## SUBDIVISION REVIEW SHEET

**CASE NO.:** C8-2020-0021.0A

**SUBDIVISION NAME:** Fort Branch Subdivision

CITY OF AUSTIN –DEVELOPMENT SERVICES DEPARTMENT  
SUBDIVISION APPLICATION – MASTER COMMENT REPORT

# FORT BRANCH CREEK SUBDIVISION

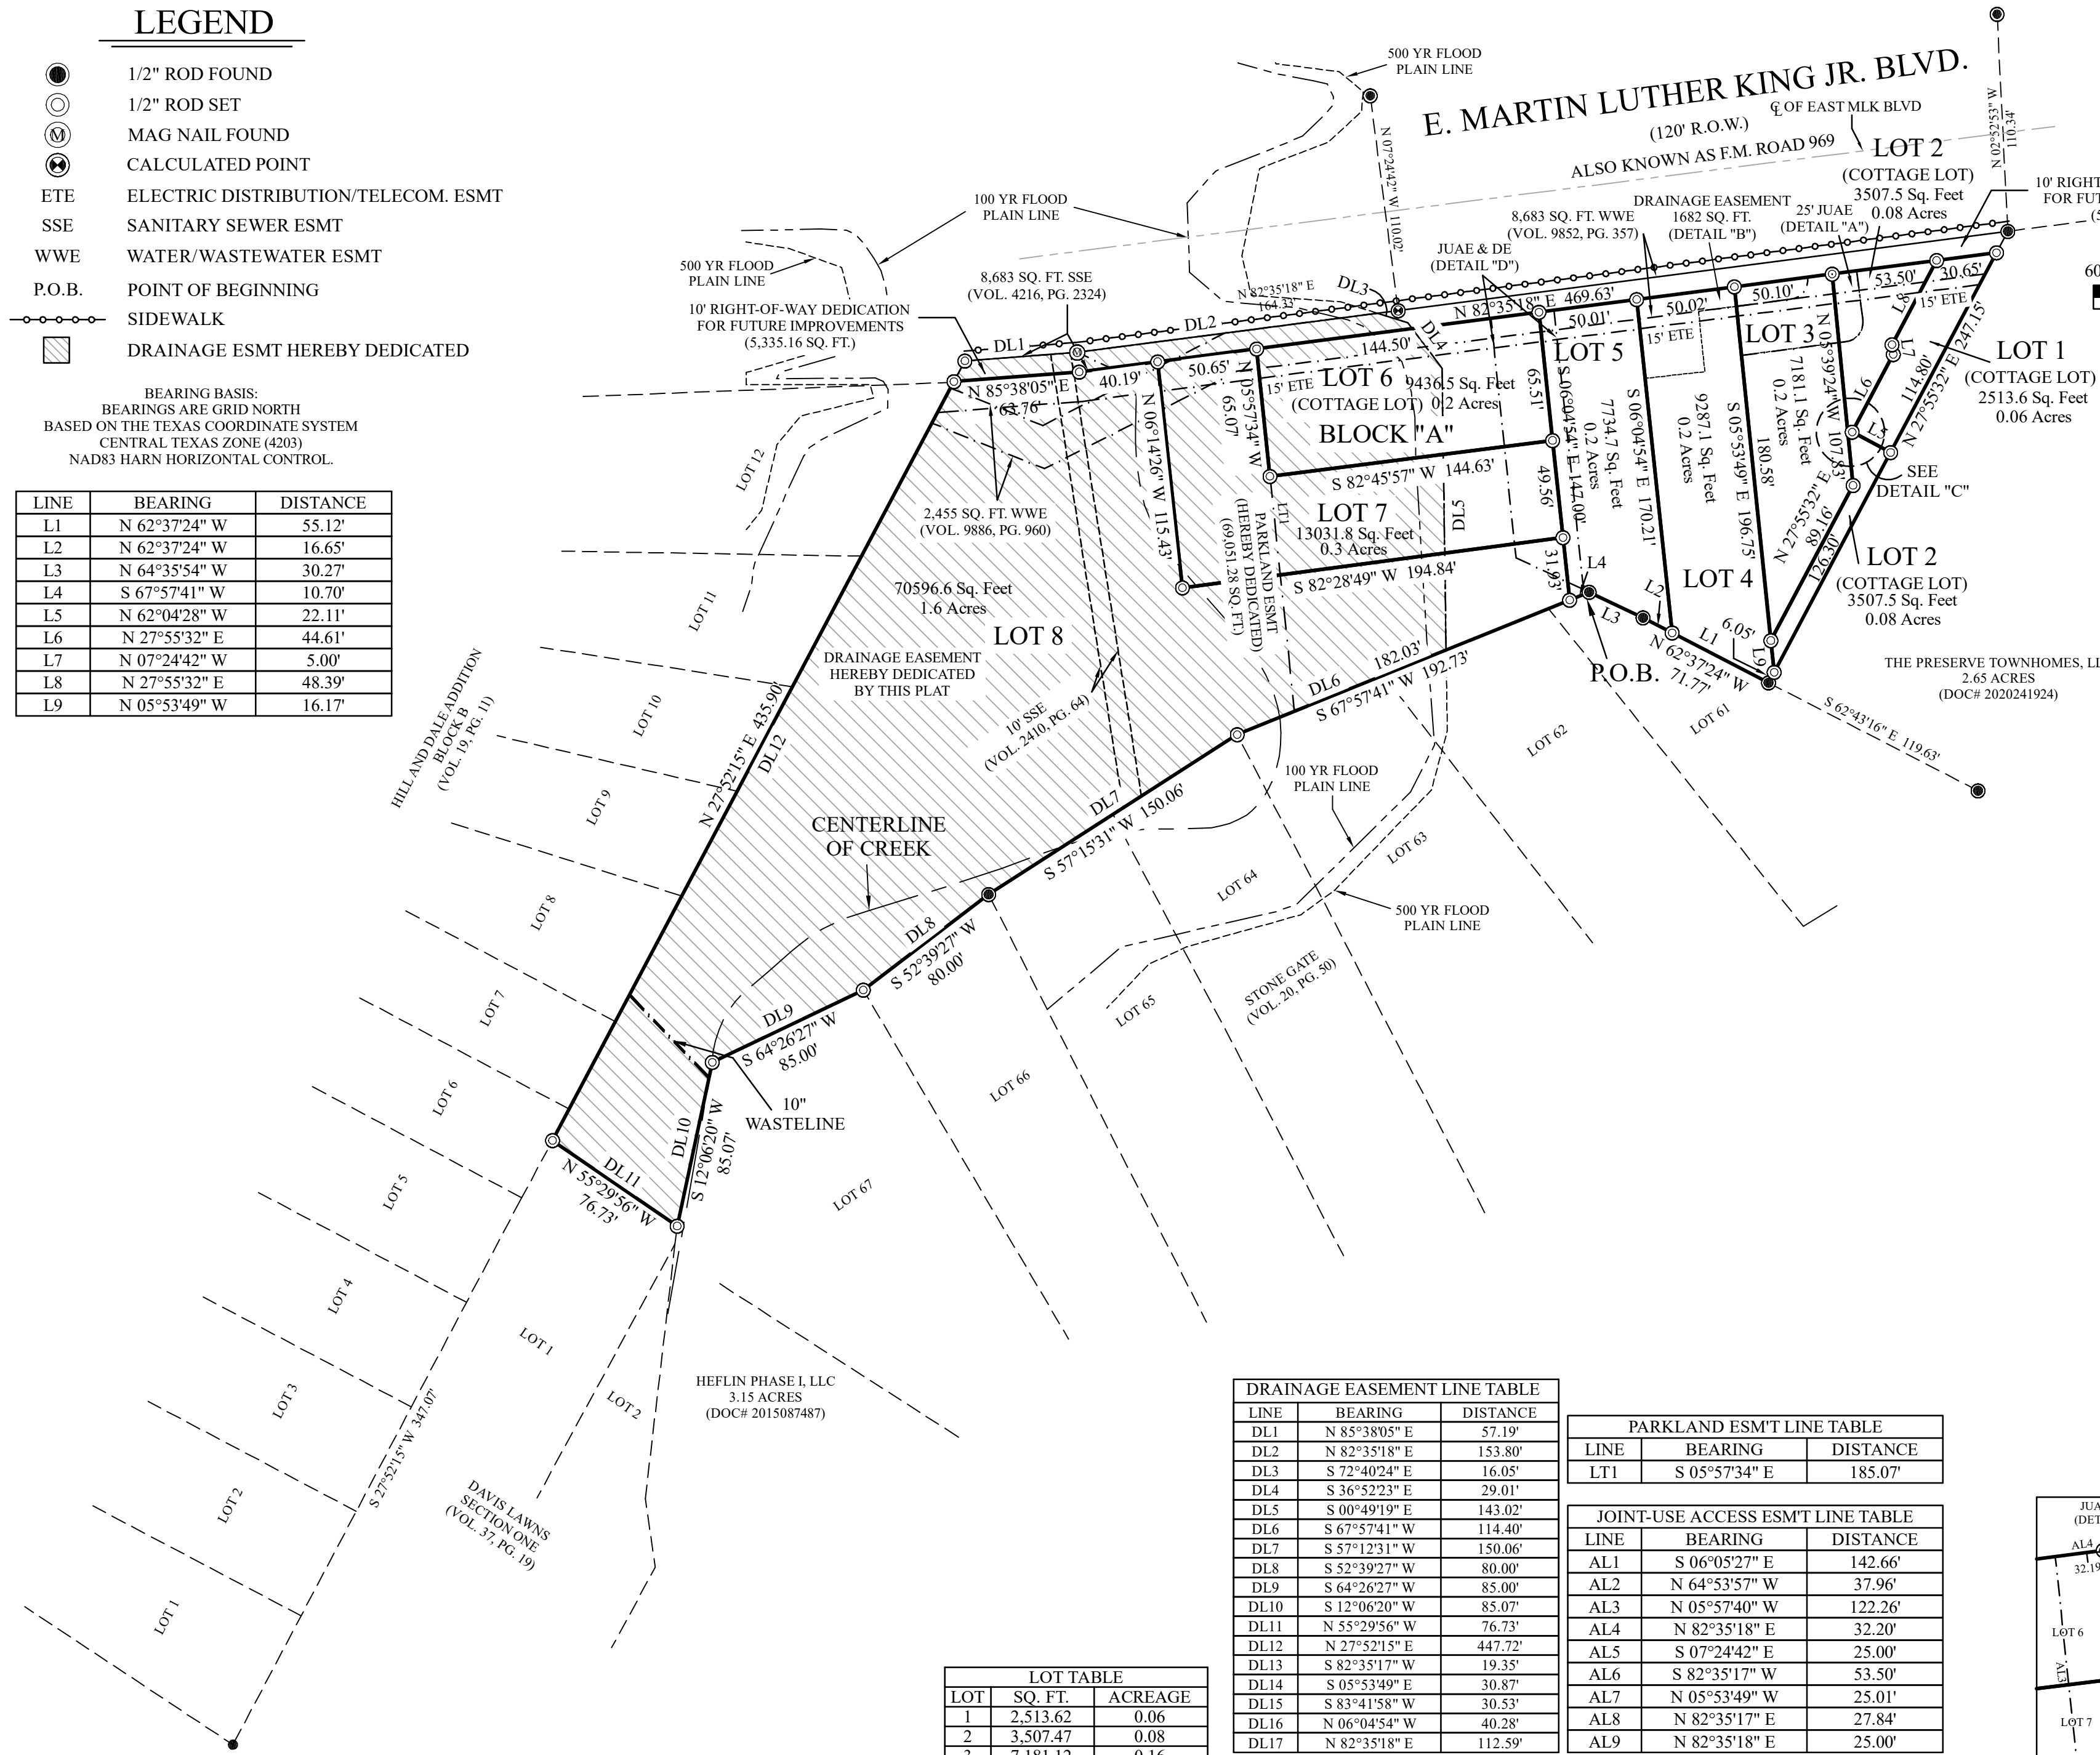
DE 6. I believe you have planned to do a restrictive covenant for private maintenance of the infrastructure? That document will need to be submitted for review and also noted in a plat note.

DE 8. Include pond layouts demonstrating that the proposed ponds will meet the DCM 1.2.4.E requirements for maintenance, inspection and safety, and contained within a drainage easement extending to the ROW.

U2: It appears the east rain garden will outlet into the west rain garden. Is the west rain garden sized to accept the outlet flows?

U3: Where does the east rain garden outlet? It appears there is a pipe connecting the two rain gardens. Please add details to make the pond flow/functions clear. Also please verify that DCM 1.2.4.E requirements for maintenance are being met.

**U2: PARD and applicant have agreed that, to meet City Code 25-1-603, the parkland trail boundary shall encompass most of the drainage easement up to the western boundary of Lot 6. Revise the parkland trail easement to reflect as much. Send updated plat to this reviewer once revised.**

**U2: Revise note to reflect total of 13 dwelling units. Park development fee is still required per § 25-1-606 (separate from fee in-lieu of land). The fee has been issued for 13 dwelling units. If the applicant wishes to post fiscal to construct park/trail improvements within the easement, please send a schematic drawing of the improvements with cost estimate equivalent to the development fee.**

SR 4. Lots should have a minimum width of 50 feet starting at the front building setback line ending 50 feet towards the rear of the lot. Verify that the lots meet the lot width requirement, as shown Lots 1, 2 and 6 do not meet the lot width requirement. L.D.C. [25-1-22\(C\)](#)  
Update 1: Label the lots that will have small lot use, such as Cottage or Urban Home uses, and provide a note listing the lots that will follow the Residential Infill Special Uses.

Update 2: Annotate on the plat that Lot 6 will have cottage use.

**Update 3:** Include a note on the plat that list the lots that will have cottage use.

U1: Please elaborate on the rain garden design (infiltration vs. filtration, R-1 table(s), etc.)

U2: Please provide a plan to satisfy ECM 1.6.7.4 regarding infiltration rate evaluation.

U3: Please verify that DCM 1.2.4.E requirements are being met.
